Niagara Falls Air Reserve Station, New York

Pre-Design Investigation Quality Assurance Project Plan Addendum No. 1

**Investigations at Sites ST009 and ST011 and
Amendment for Site LF008**

May 2014

FIGURE 17B
LF008 - Site 3
Proposed Sample Locations

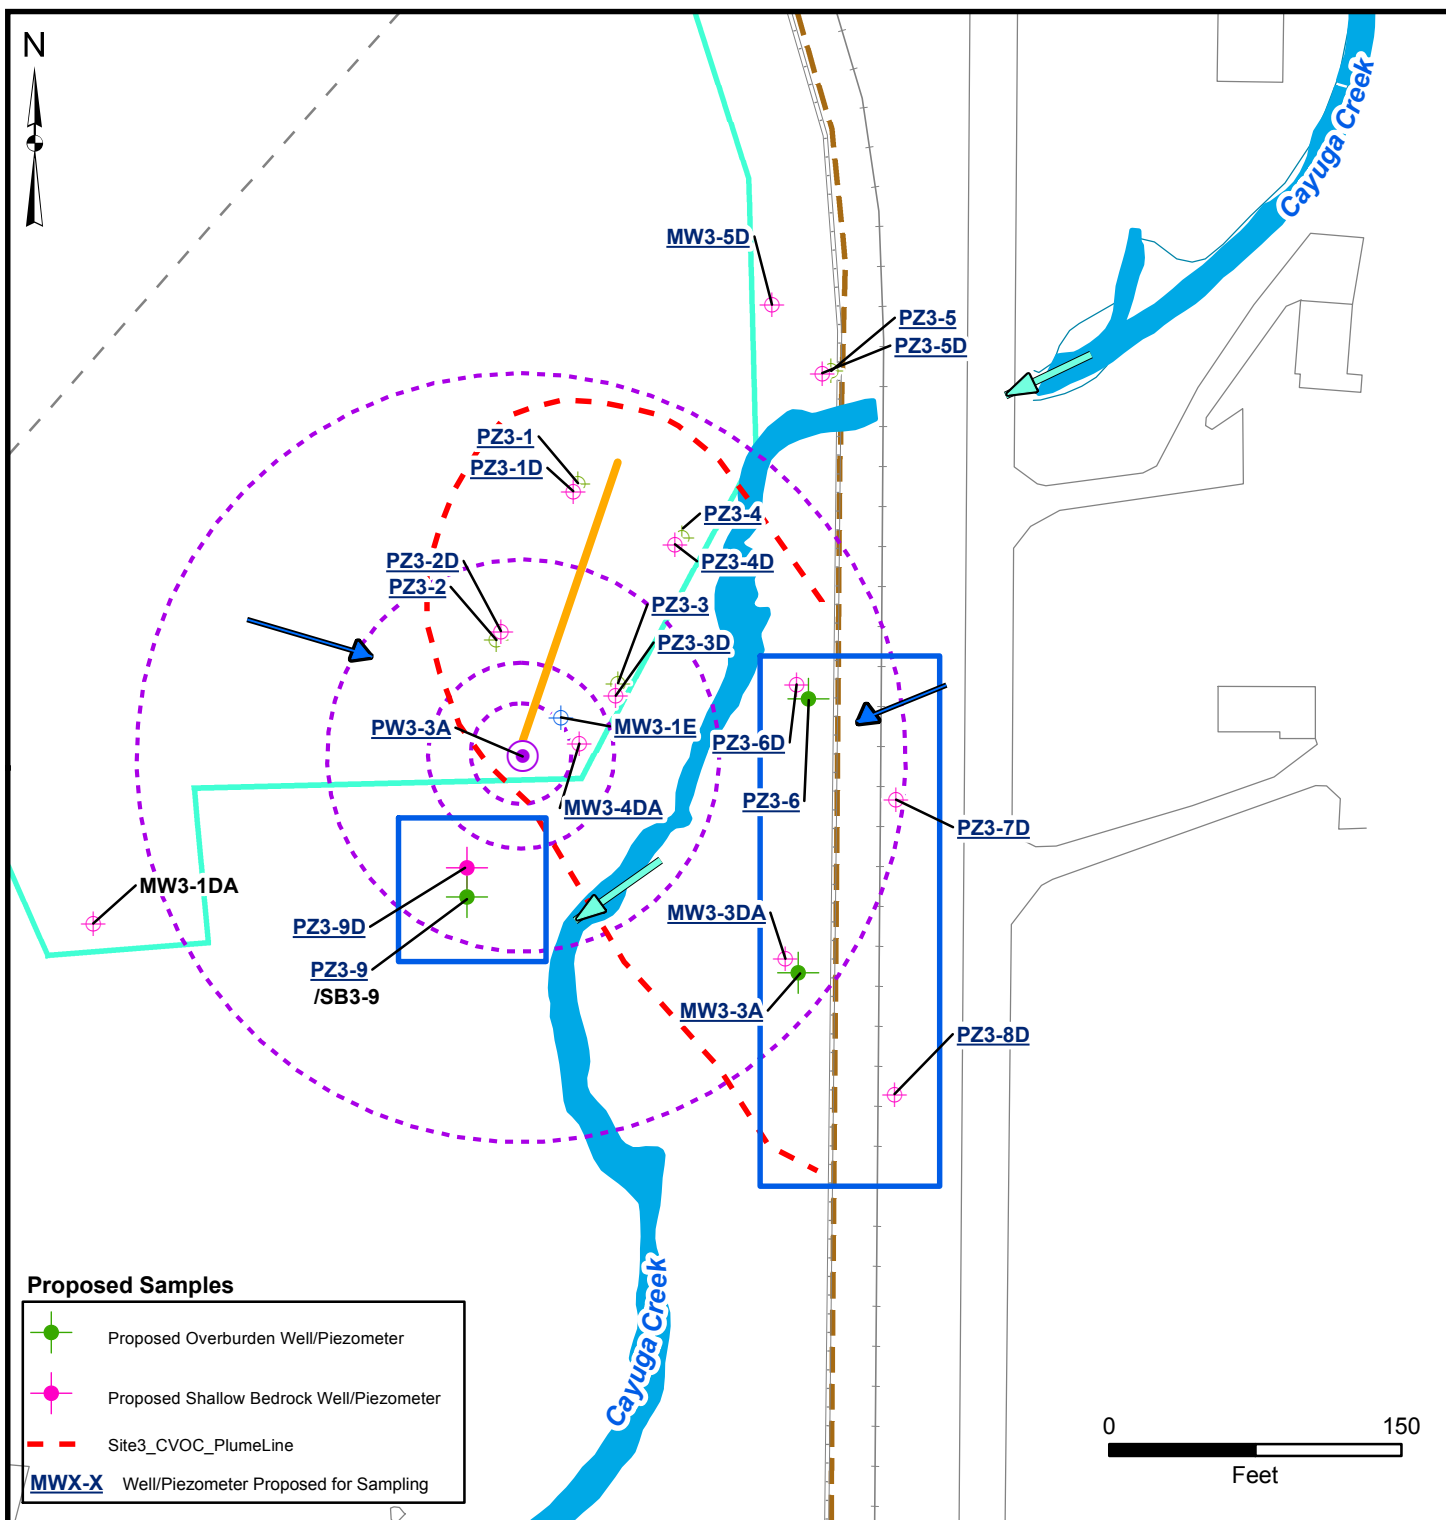
**RE: Niagara Falls Air Reserve Station – Pre-Design Investigation Modification for LF008 (Site 3)
– Overburden Well Locations**

Versar Inc., and its teaming partner, EA Engineering, P.C. and its affiliate EA Science and Technology (EA) are submitting this letter regarding the pre-design investigation at LF008 (Site 3). The existing pre-design investigation included installation of two overburden monitoring wells east of Cayuga Creek. In the Pre-Design Investigation Quality Assurance Project Plan (EA 2014)¹, these wells were shown paired with existing shallow bedrock wells located east of the Niagara Falls Air Reserve Station property fence. After further evaluation, EA is proposing to move these wells west of the fence and pair them with other existing shallow bedrock wells (Figure 17B, attached).

The primary purpose for these new overburden monitoring wells is to provide additional data to evaluate the hydraulic connection between the overburden, shallow bedrock, and surface water. These overburden wells will augment existing shallow bedrock well locations east of the creek, forming a well cluster. This will allow for calculation of vertical hydraulic gradients between overburden and shallow bedrock at these locations, as well as evaluation of hydraulic changes during the aquifer test. Shifting the location of the two proposed shallow bedrock wells closer to the creek, versus the originally proposed locations, will not impact the effectiveness of the monitoring network in evaluating groundwater flow conditions. In fact, it is anticipated that the newly proposed locations will provide better data to evaluate the hydraulic connection between groundwater and surface water, given the reduced distance from the creek channel.

We are requesting approval to install these wells at the revised location. If you have any questions, please feel free to contact me at 315-565-6570.
